Murphy Environmental Hollywood Ltd

Re.: Murphy Environmental Hollywood Ltd. (MEHL), EPA Ref. W0129-03

Murphy Environmental Hollywood Ltd Application for Waste Licence Ref. WL 129-03 - Clarification in accordance with Article 16(1) of the Waste Management (Licensing) Regulations application number: W0129-03

re : Notice in accordance with Article 16(1) of the Waste Management (Licensing) Regulations

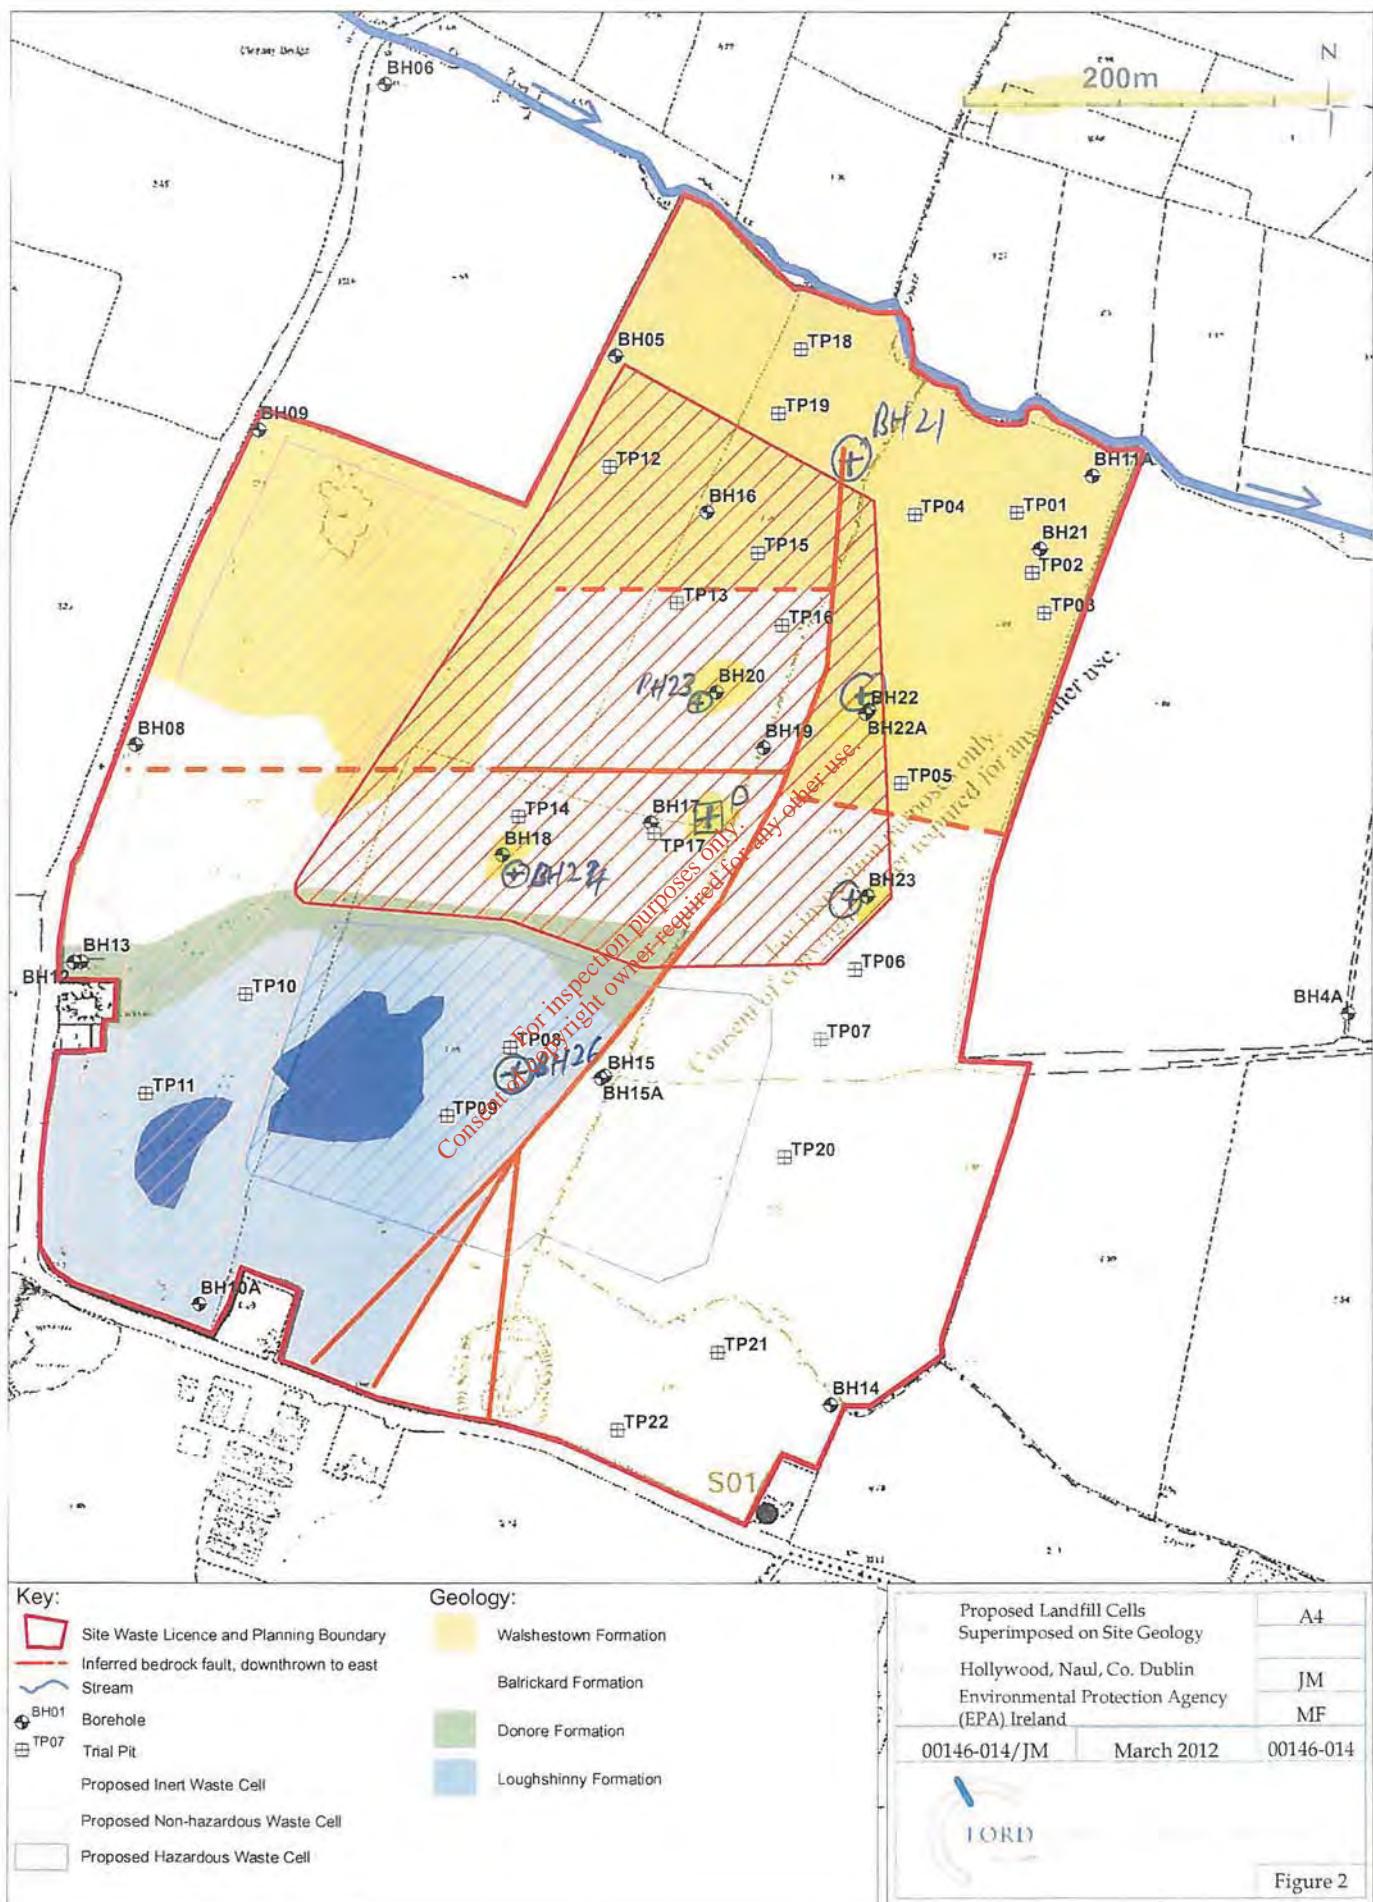
1. The well in the non-hazardous cell (BH26) might better serve as a monitoring well, not the pump test well.
2. Proposed well to the north (BH21) targeting the fault zone. It may be preferable for this well to be closer to the suggested end of this north-south fault (on your plan) and not at the north boundary of the site. It is designed to intercept the fault zone in this area. With this as the target our sense is having two wells one to 40m depth (screened 20-40m) and a second to 60m (screened 40-60m) may be better than the 90m option, recognising we may not reach the Loughshinny.

Not all boreholes need to be cored. However at the proposed locations near existing boreholes BH20, BH22/22A and BH23, coring the deep borehole would help a lot to understand the geology and aquifer units and fracture distribution and therefore could be invaluable. The pump test well might also of course benefit from being cored. If four is seen as prohibitively expensive then it may be appropriate that the pump test plus one of the two boreholes to the east of the main fault are prioritised for coring (so 2 not 4 cored).

It is noted that the MEHL numbering system for the proposed new wells should be changed as there are already boreholes with the same reference (e.g., BH22 and BH23) which will be confusing later.
